Council Ref: DA2025/0573

ENGINEERING REFERRAL RESPONSE (DA2025/0573)

RE: PROPOSED RESIDENTIAL DEVELOPMENT WITH BASEMENT CARPARK AT 94-96 PARK STREET AND 4 KUNARI PLACE, MONA VALE NSW

Figure 1 – TUFLOW Model of Contributing Catchment (RTS)

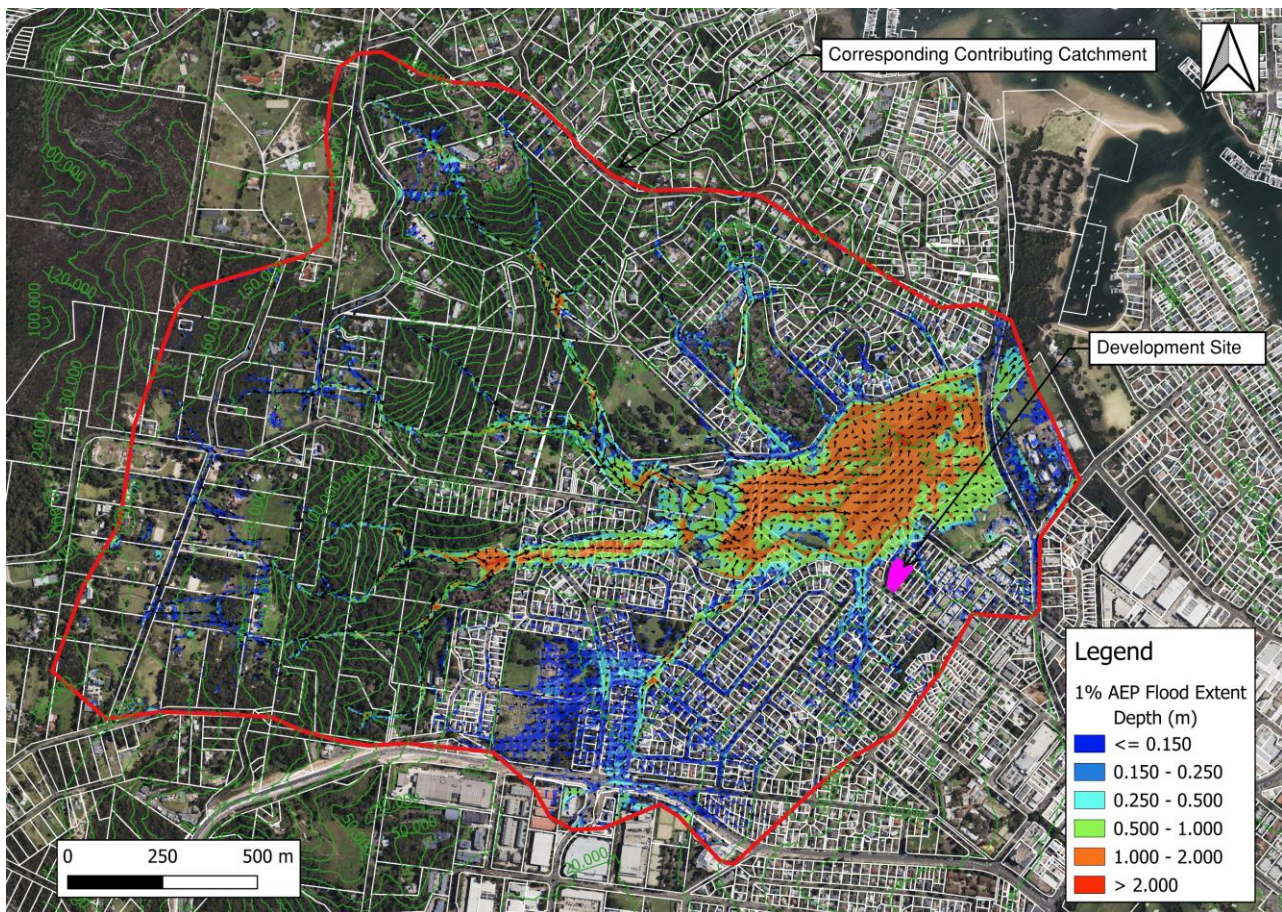
The subject site is located at the lower end of the Cahill Creek catchment, approximately 40 m upstream of Kunari Place, which is flood-affected during the 1% AEP event. While the site itself is not flood-affected, Council flood mapping confirms that downstream areas are impacted during major storm events, and this zone functions as a natural detention area due to downstream culvert constraints and tailwater conditions.

This part of the catchment is considered downstream controlled, meaning local flood levels are dictated more by downstream backwater effects than by peak inflows from the site or immediate surrounds. Conceptual TUFLOW flood modelling prepared for this assessment reflects similar results to Council's adopted flood study, confirming that the adjacent golf course and culvert draining Cahill Creek below Pittwater Road act as a detention system, temporarily storing and attenuating upstream flows during flood events. Refer to Figure 1 attached.

Figure 2 – 20% AEP Event Hydrographs Comparisons (DRAINS – RORB)

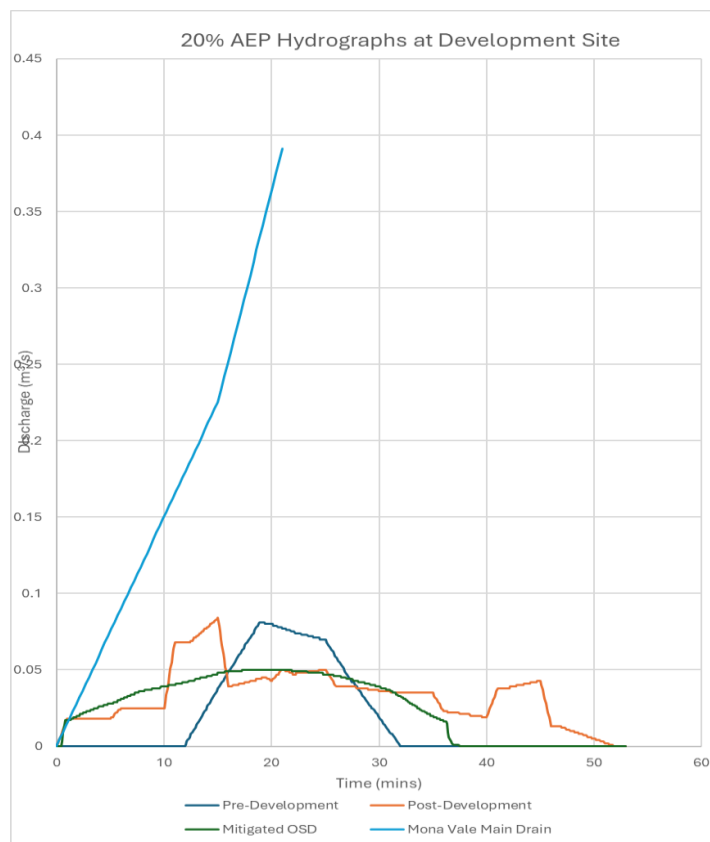
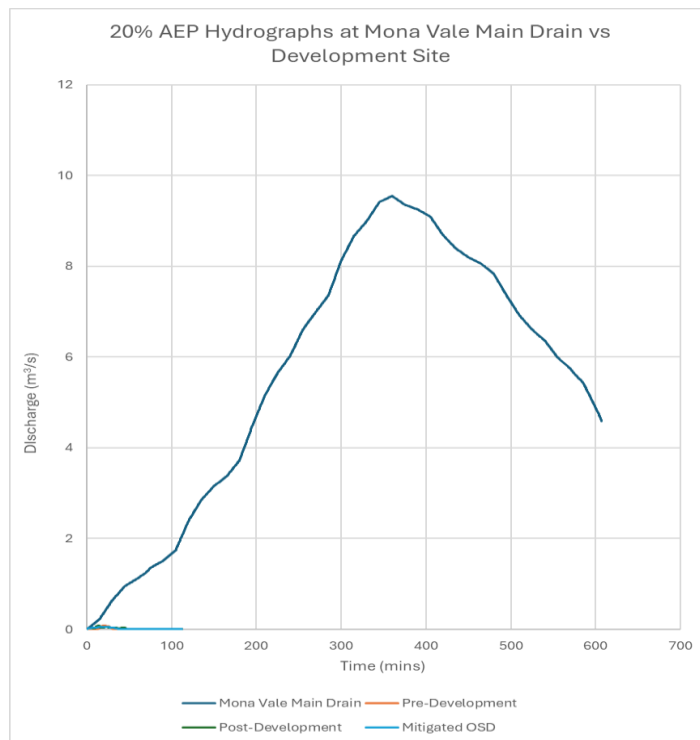
As requested, we have undertaken hydrological and hydraulic analysis of the development site's runoff hydrograph, compared to that of the broader Cahill Creek catchment and Mona Vale Main Drain system. Refer to Figures 2 to 4 attached.

- a. The site contributes less than 1% of the peak flow within the downstream system in the 1% AEP, 5% AEP, and 20% AEP storm events.
- b. Runoff from the development site is predicted to peak before the downstream catchment hydrograph, reducing any potential for timing-based flood impact.
- c. Application of OSD at the development site would offer negligible benefit and possibly introduce misalignment with catchment peak flows.
- d. Council's policy seems to recognise that in such cases, OSD may not be appropriate or required.

Figure 6 – Rainwater Tank Cumulative Frequency Graph (MUSIC)

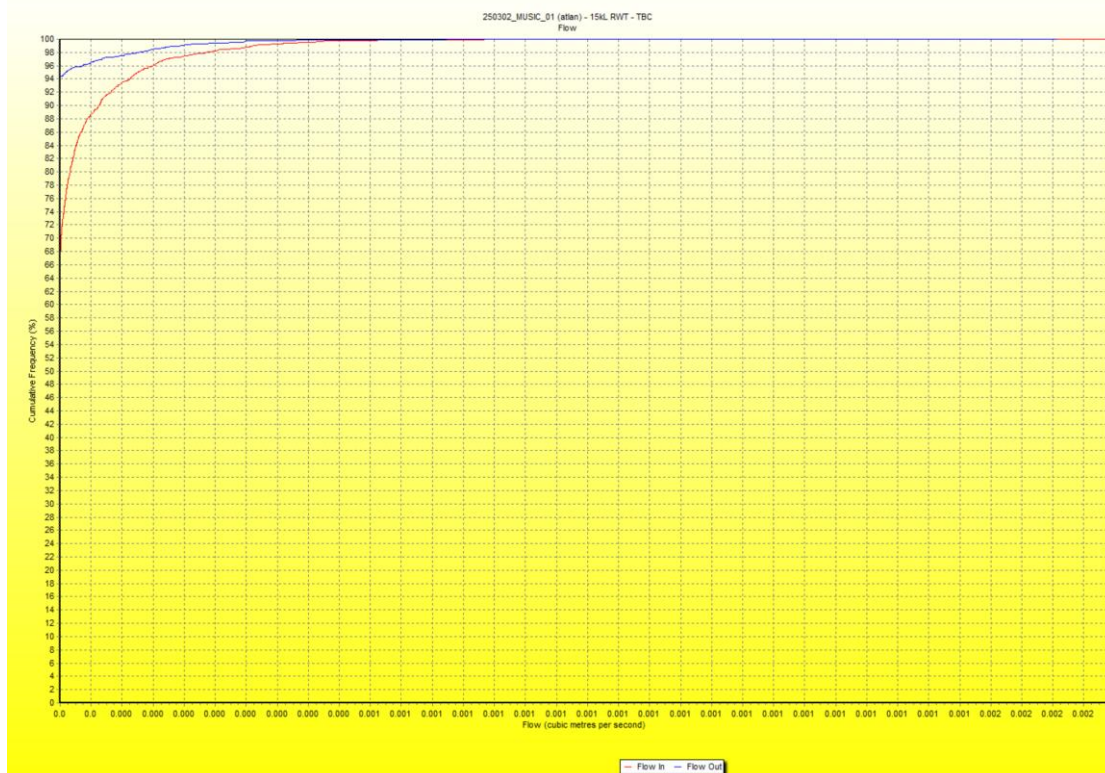
- a. Roof Catchment (1,035 m² connected to 15,000 L rainwater tank)
 - Annual inflow volume (roof runoff): 671 kL/year
 - Annual reuse supplied (toilets, laundry, landscaping): 447 kL/year
 - Reuse efficiency: 67%
 - Reuse demand met: 26%
 - Volume discharged to system (pipe out): 224 kL/year
 - No overflow via weir or bypass routes recorded.
- b. Development Site Summary
 - Total site runoff (post-development): 1.89 ML/year (from 2.33 ML/year pre-dev)
 - Runoff volume reduction: 19%
 - Reuse applied only to roof areas; remaining site flows discharged via standard drainage.

The results show a high reuse efficiency, with the rainwater harvesting system meeting a significant portion of the development's non-potable water demand. Specifically, the 15,000 L rainwater harvesting system receives approximately 671 kL/year of roof runoff from 1,035 m² of roof area, of which 447 kL/year is reused internally, equating to a 67% reuse efficiency. The volume discharged from the rainwater harvesting system to the downstream system is limited to 224 kL/year, with no overflow via weir or bypass.
